RIA RFQ FINAL DRAWINGS

Review by W. Clark, F. Martinez, J. Rathke, & D. Schrage

Figure I: RIA RFQ END FLANGE BRAZE JOINT

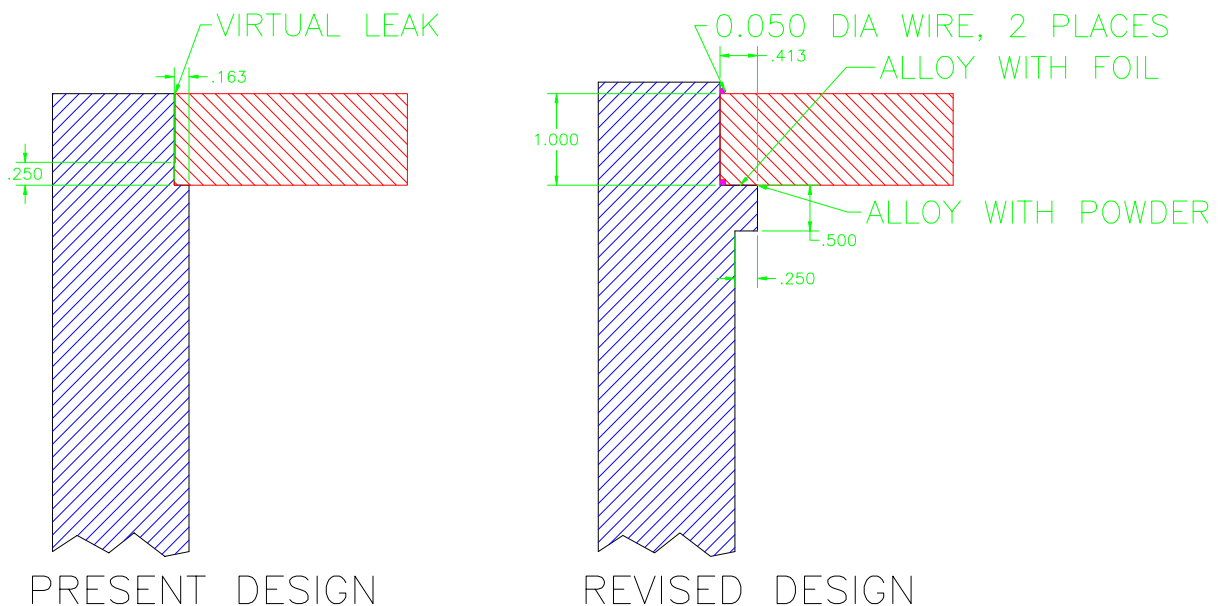
G12827: The braze joint at the end flange is undesirable as drawn. While the 0.163 inch joint width at the minimum distance from the 21.875 inch diameter cylinder on the barrel to the 22.200 inch octagon nearly meets the LANL 0.188 inch minimum width for a braze joint, it is not structurally robust. In fact, if one takes into account that there must be a chamfer at the inside corner to assure fit up, a 0.030 inch chamfer reduces the width of the braze joint to as little as 0.133 inch, far too small. The total area in brazed contact at the base of the flange will be about 30 square inches. In addition, having only a 0.250-inch length of the flange ID brazed leaves a virtual leak volume.

We had discussed putting an alloy groove into base of the upper flange and into the face of the lower cavity barrel. On closer examination, this is not feasible given the small areas. A better, more robust solution is shown on Figure I below:

First, the full length of the inside diameter of the flange must be brazed. This will provide a more robust structure and eliminate the virtual leak. The RFQ barrel should stand proud about 0.125 inch. This will provide a place for the 0.050-inch diameter alloy to be wrapped. Adding some

powder in this area would also be worthwhile. Alloy starvation will have an inconvenient consequence. It might be worthwhile to provide a small chamfer on the end of the barrel to aid in positioning the flange. This would be machined off when the ends of the RFQ segment are faced.

The RFQ barrel should have a thick feature at the ends. This will allow the braze joint to the flange to be about 0.250 inch wide at the narrowest point. This doubles the braze area at the base of the flange to nearly 50 square inches. Foil alloy (0.002 inch thick) should be placed at the base of the flange. In addition, there is a groove at the inner corner of the flange for 0.050-inch diameter foil alloy. Lastly, powder alloy can be placed at the outside of the RFQ barrel.

What is shown on Figure I is closer to the design that we used on the LEDA RFQ. The diametral clearance between the RFQ barrel and the inside diameter of the flange was 0.0002 to 0.0007 inch. This made for a very tight CuSil joint. Remember to machine the final bore of the flanges AFTER the ends of the RFQ barrel have been machined.
